DATE:	October 16, 2026
MAI NO.:	24042
OPSC APPL. NO.:	
DSA APPL. NO.:	02-123774
DSA FILE NO.:	10-126

NEW TEMPERANCE ELEMENTARY SCHOOL

SANGER UNIFIED SCHOOL DISTRICT
SANGER, FRESNO COUNTY, CALIFORNIA

ADDENDUM NO. 3

ES1.2R

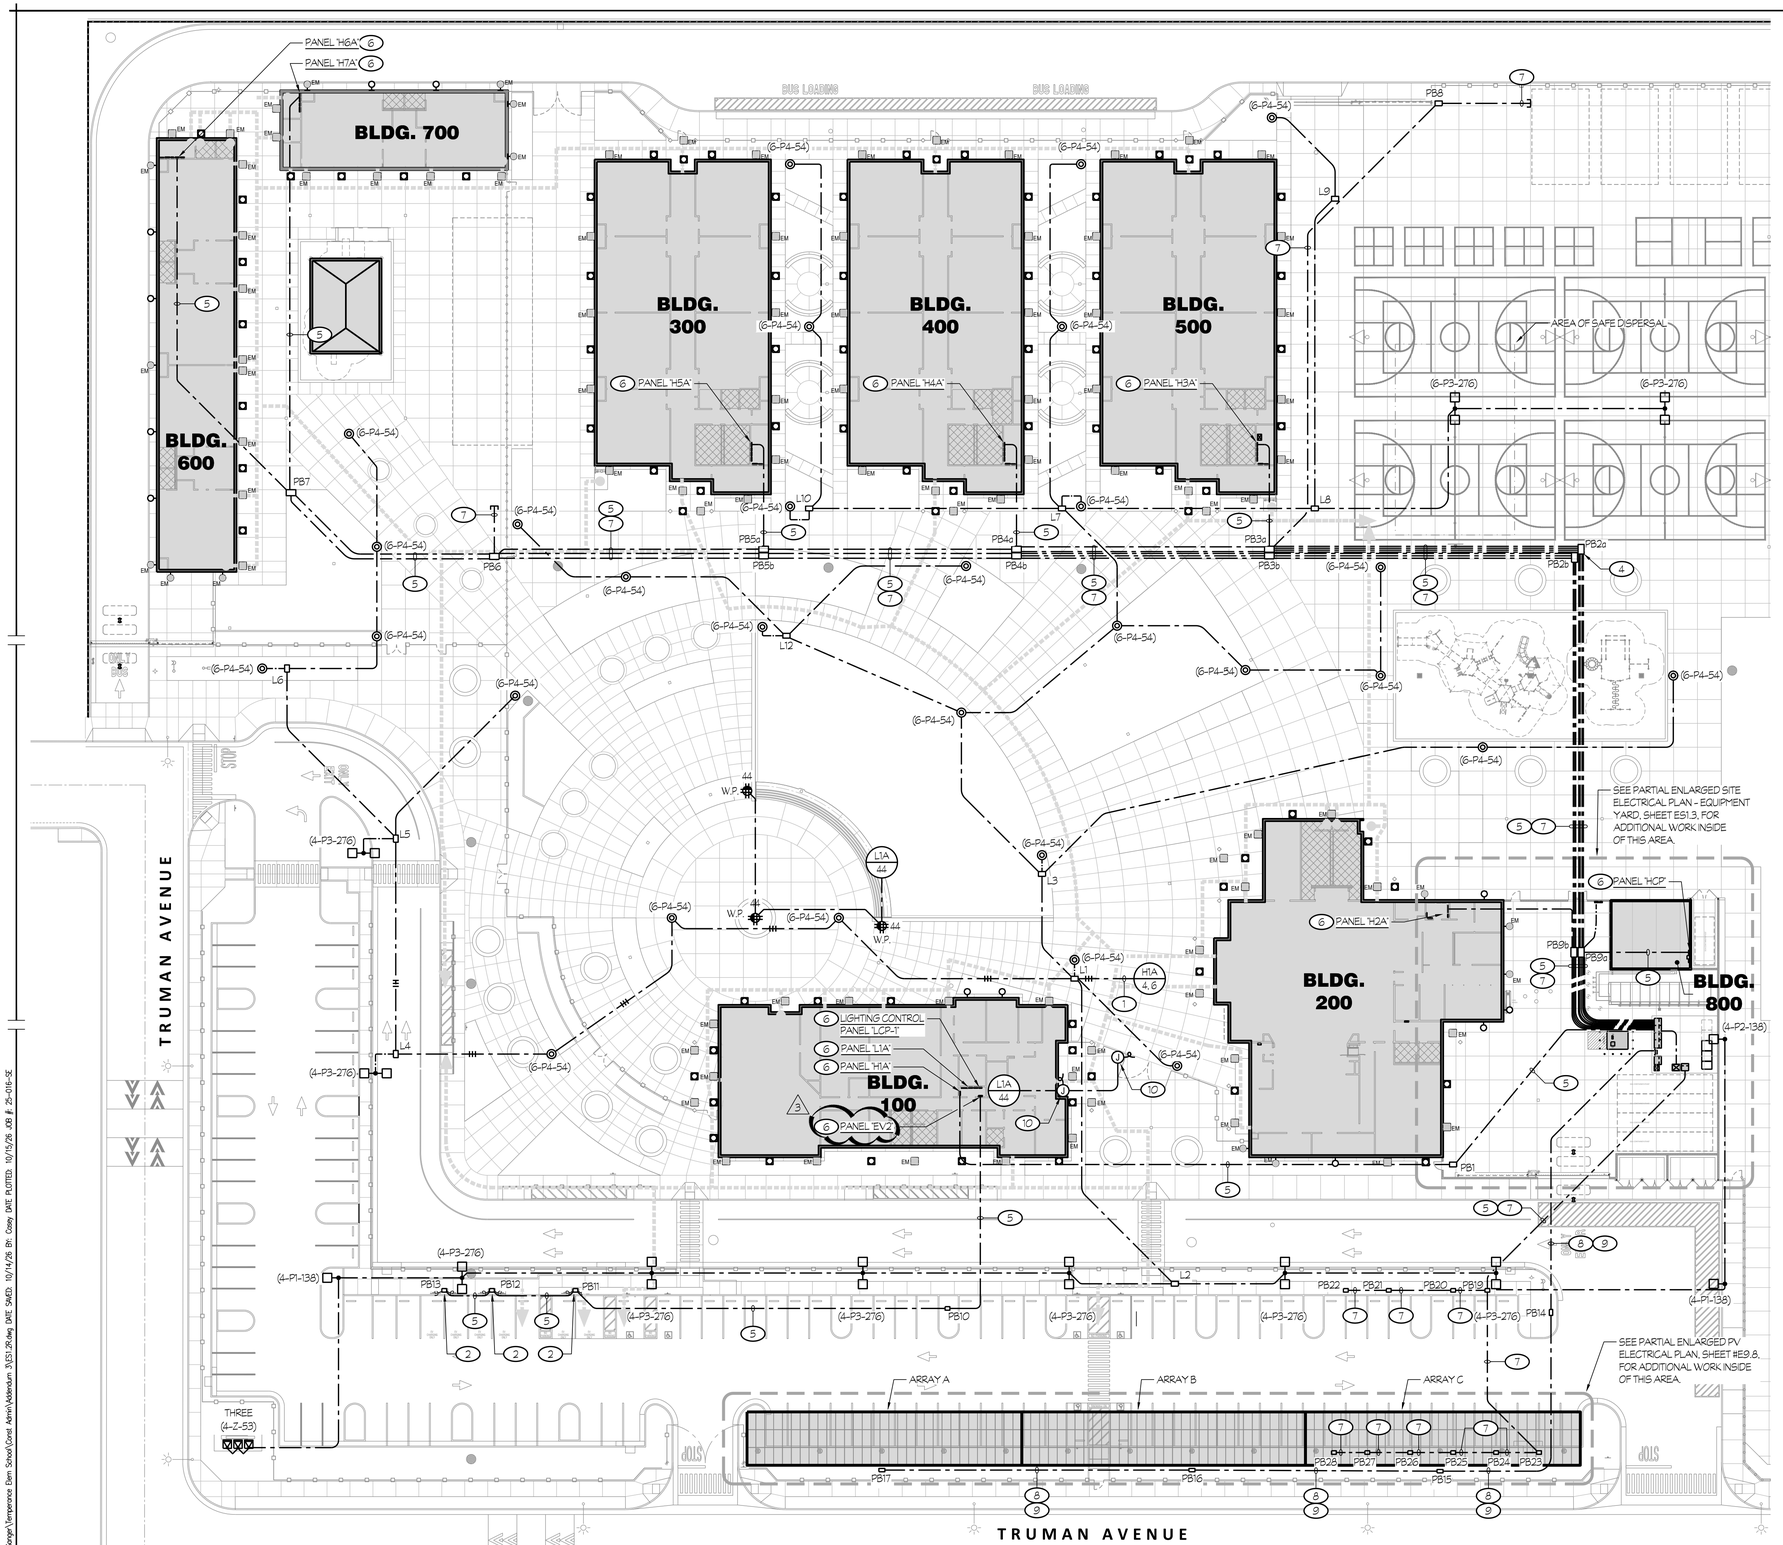
Item #1, Sheet #ES1.2R:
A. See revised Panel callout.

ES1.3R

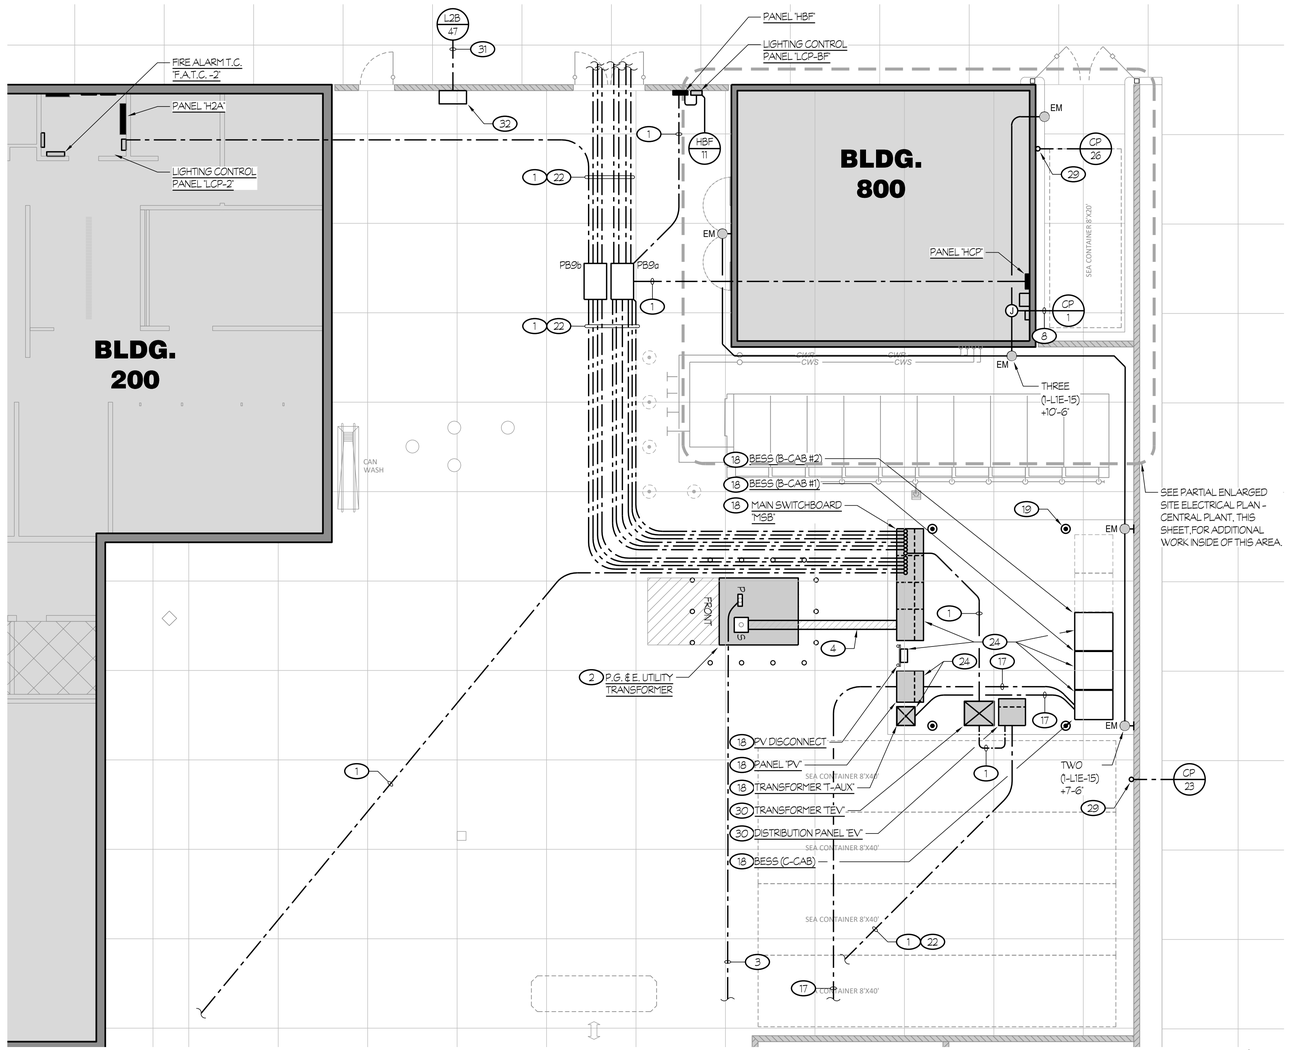
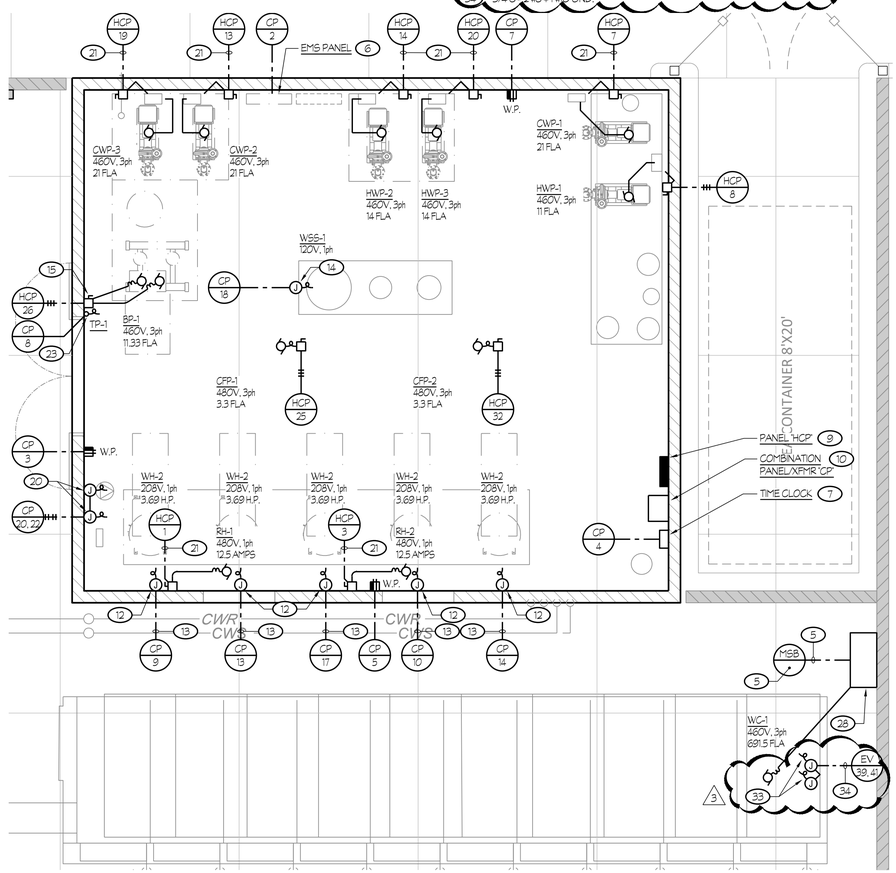
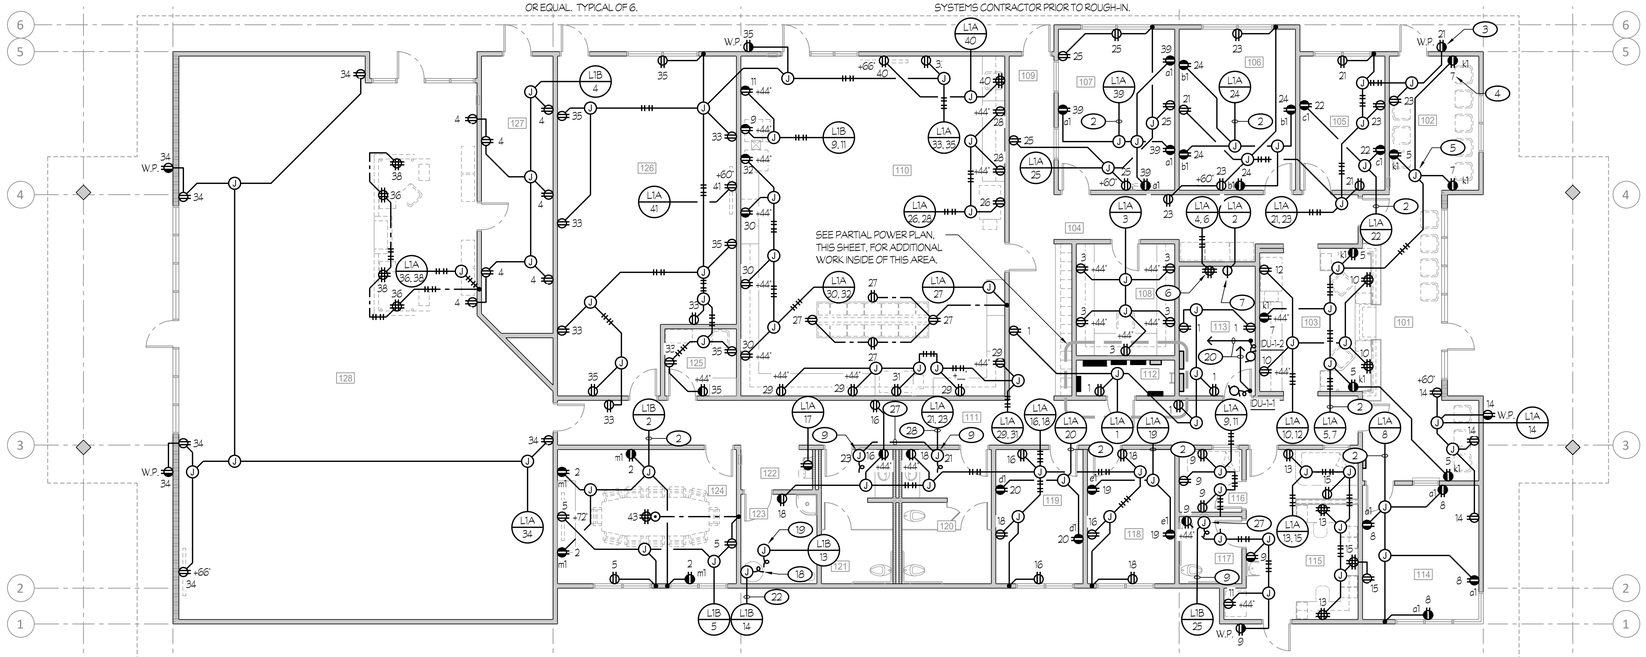
Item #2, Sheet #ES1.3R:
A. See new connections for Chiller Unit Heat Trace connections.

E1.1R

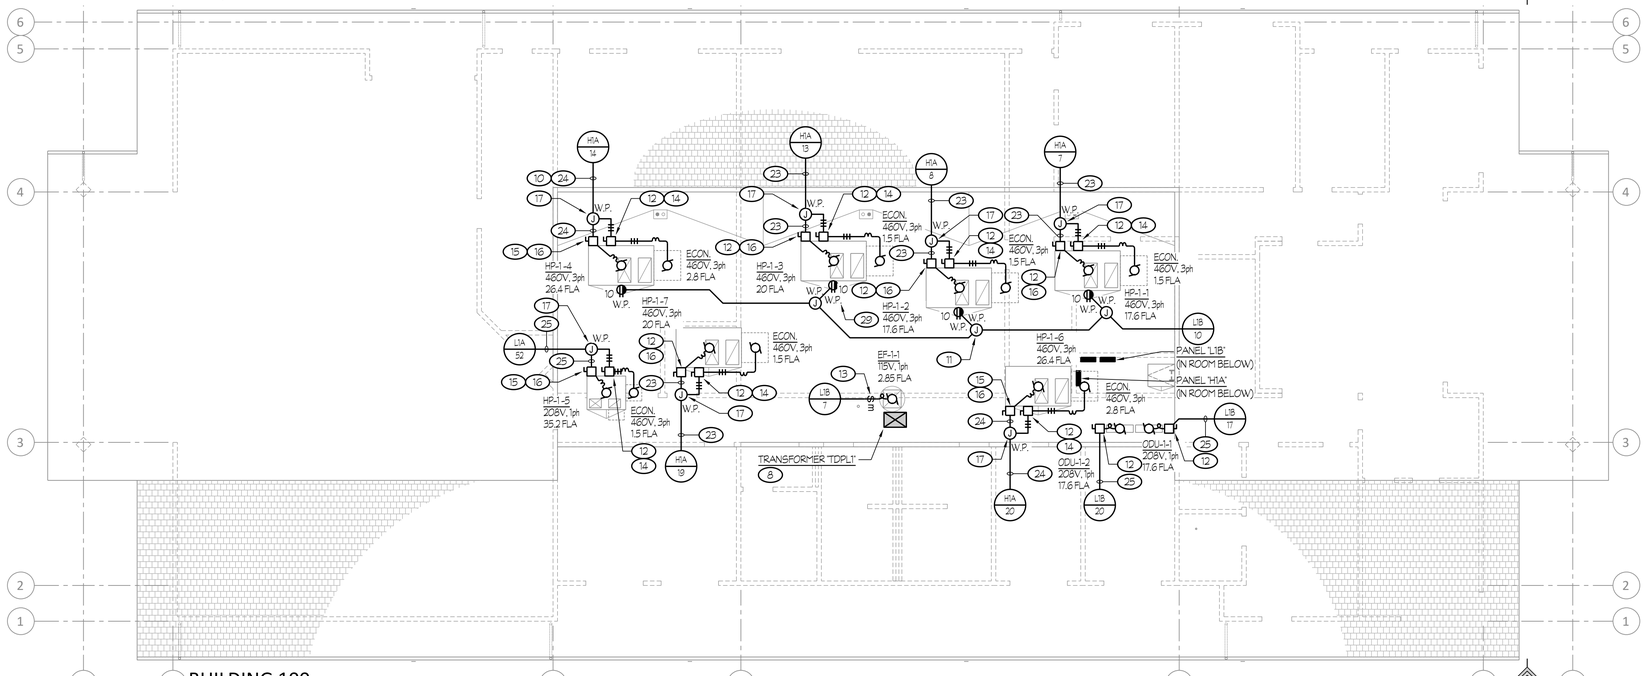
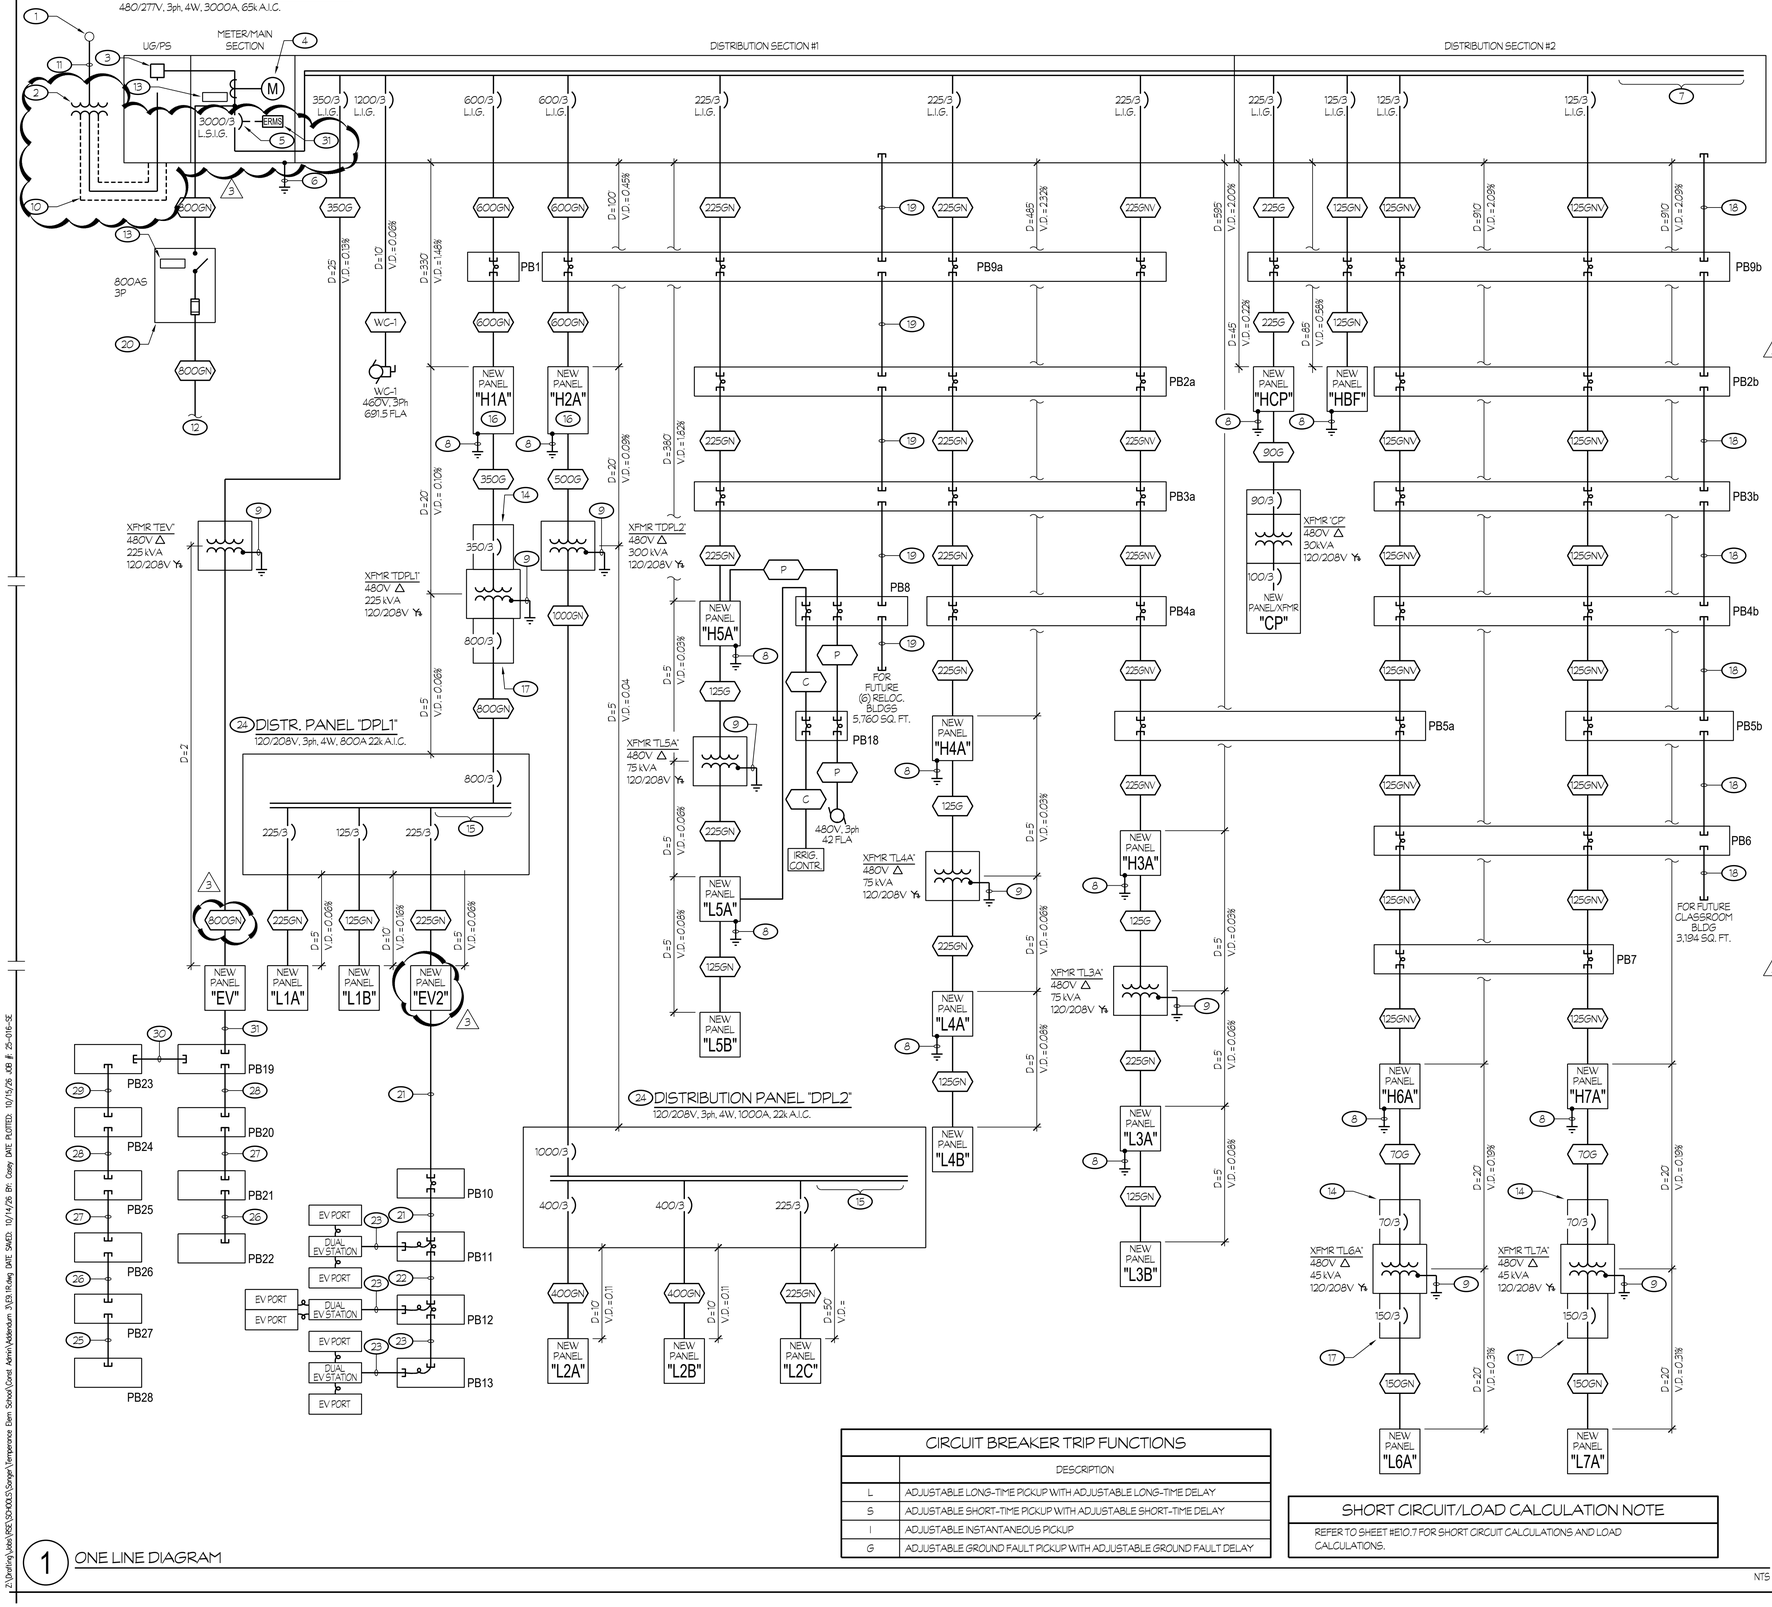
Item #3, Sheet #E1.1R:
A. See revised callout for Panel "EV2".
